**External Consultants Report – Peer Review
of Lighting Impact Assessment**

PEER REVIEW OF LIGHTING IMPACT ASSESSMENT

PROPOSED DIGITAL SIGNAGE

1 MISSENDEN RD, CAMPERDOWN

Figure 1. Model of site showing signage location and the north facing facade at 69-71 Parramatta Rd as well as the location of new development at 12 Marsden St.

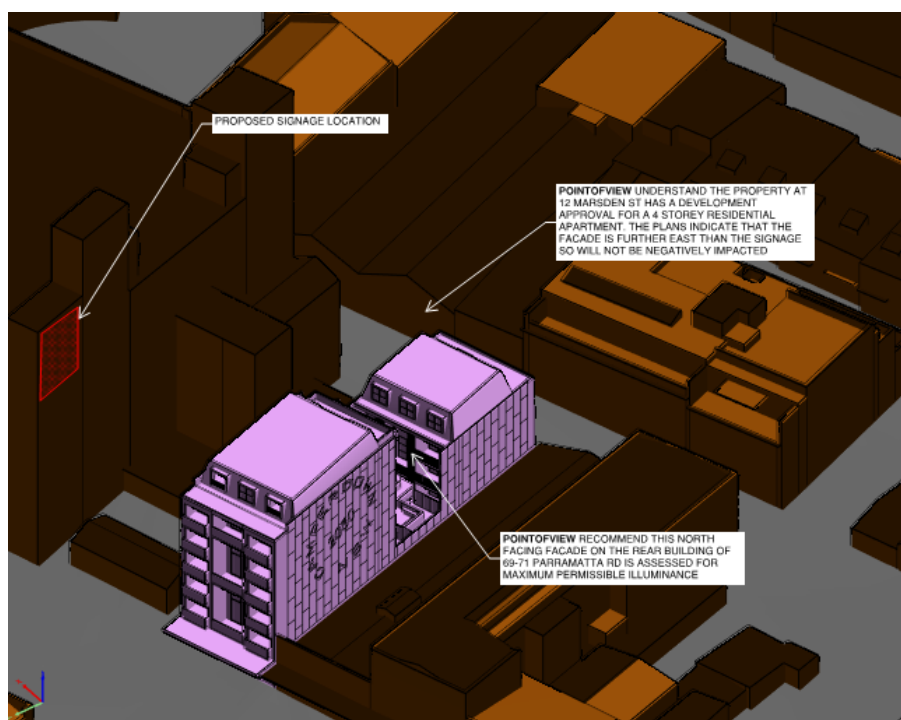
The Lighting Impact Assessment illustrates calculations on the northern facades of the properties on the south side of Brodrick St, the north facing facades of the properties at 69-71 Parramatta Rd and the south facing facades of the properties on the north side of Parramatta Rd. Due to its proximity to the proposed signage, the most at risk property of being negatively impacted by the proposed signage is the rear building façade (north facing) of the property at 69-71 Parramatta Rd. Refer to Figure 1, below. The windows on this façade are windows in living areas and bedrooms. It is our opinion that the assessment captures all the residential and commercial facades potentially impacted by the new digital signage.

Figure 2. Extract of Plans of new approved development at 12 Marsden St showing the habitable windows on the Brodrick St façade in relation to the vertical plane of the proposed signage.

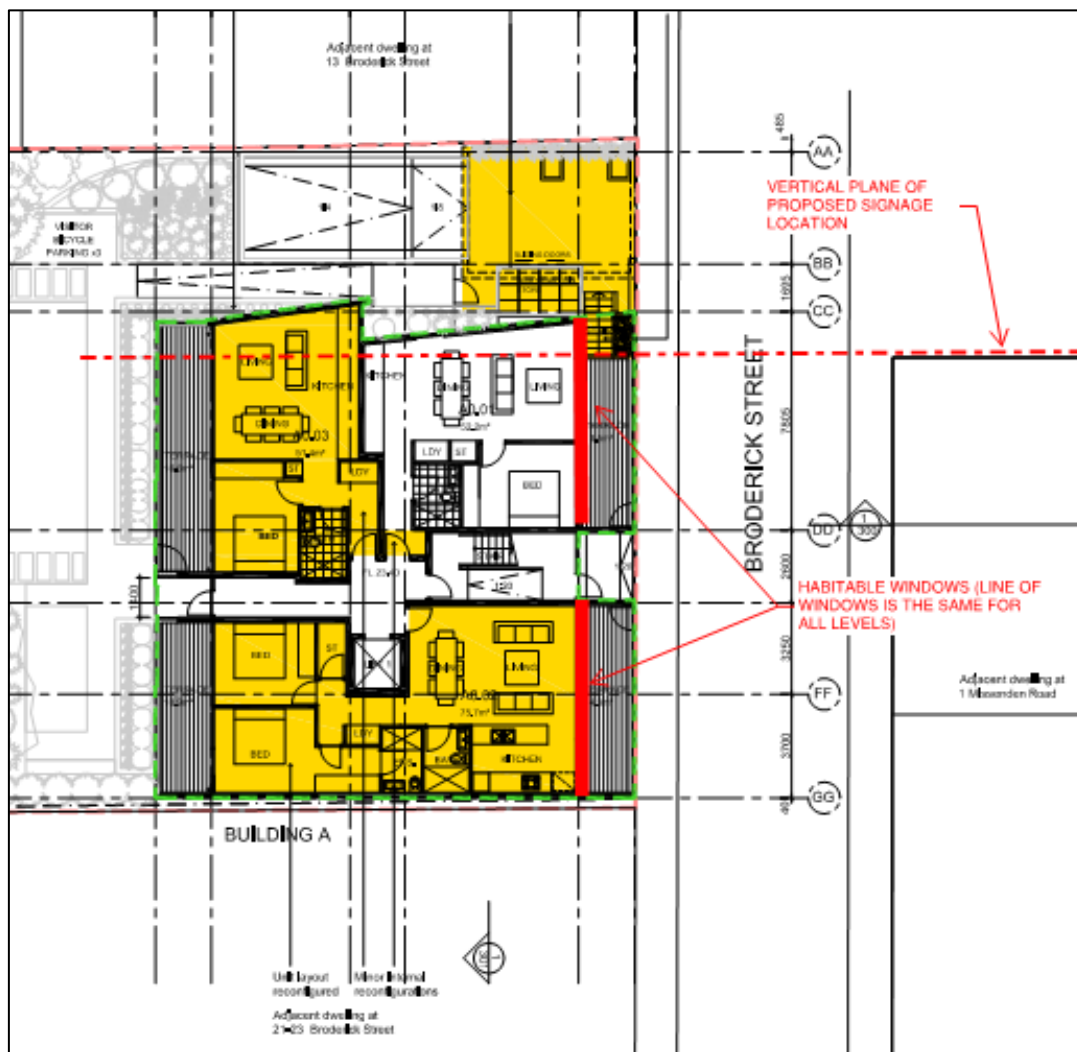
POINTOFVIEW understand there is residential development approval for the property at 12 Marsden St with Building B backing onto Brodrick St. Figure 1 shows the location of the future residential development. As the plans in Figure 2 indicate, the majority of the habitable windows on the northern side of Building A (backing onto Brodrick St) are east of the vertical plane of the proposed signage and therefore. The portion of habitable windows west of the vertical plane of the proposed signage have been assessed adequately, and this is outlined in Section 4.1.

Figure 3. Extract of Lighting Impact Assessment, Appendix D with highest illuminance levels calculated at 128 Parramatta Rd south facing facade, 69-71 Parramatta Rd north facing facade or rear building and the proposed development at 12 Marsden St Building A north facing facades.

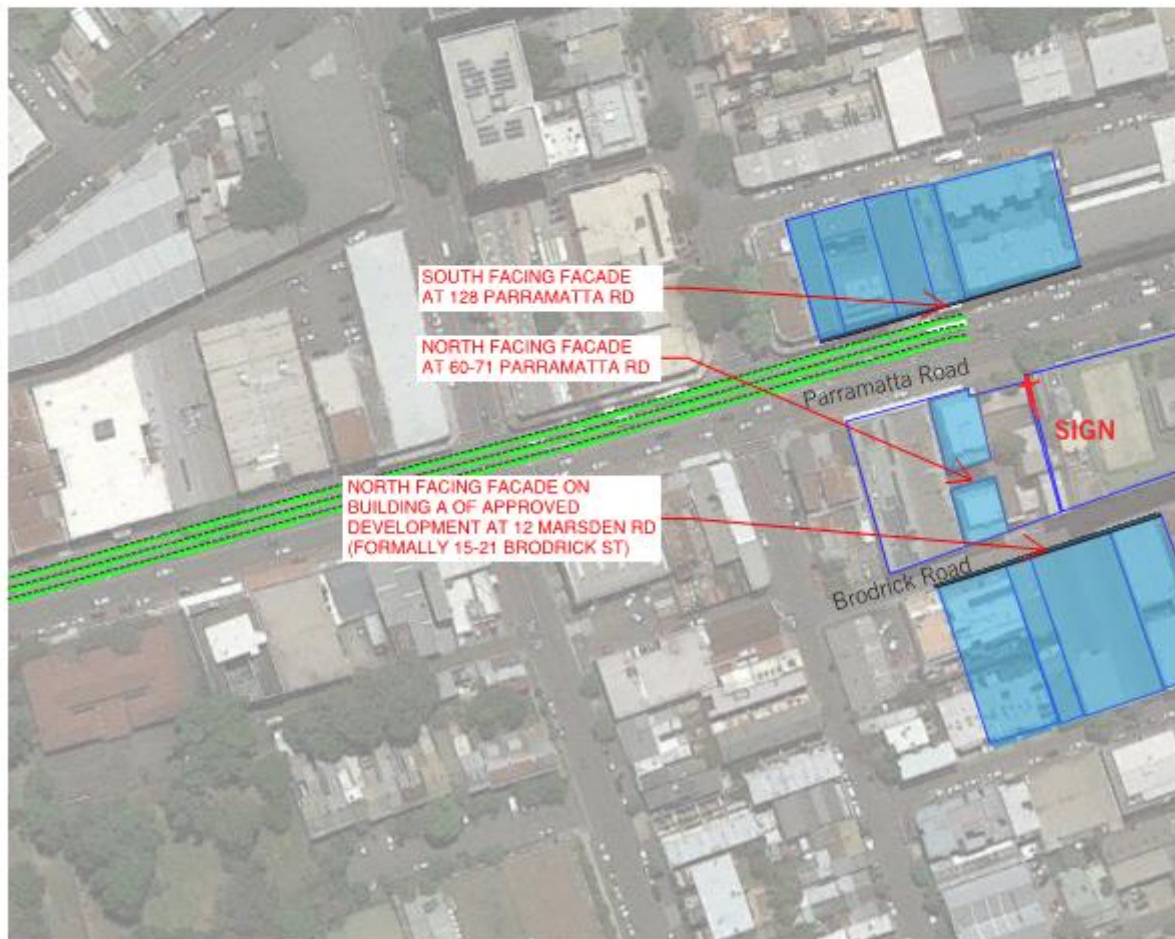
In our opinion, the Lighting Impact Assessment demonstrates compliance with the lighting parameters listed below, as required in the relevant legislation, for all of the adjacent properties. This includes the south facing façade at 128 Parramatta Rd, the north facing façade of the property at 69-71 Parramatta Rd and the proposed residential development at 12 Marsden St (formerly 15-21 Brodrick St). This is demonstrated in Figure 3, on the following page.

Provided the signage is operated within the dimming levels outlined in Section 5 of the Lighting Impact Assessment for the different times of day, it is our opinion, that the compliance is demonstrated accurately.
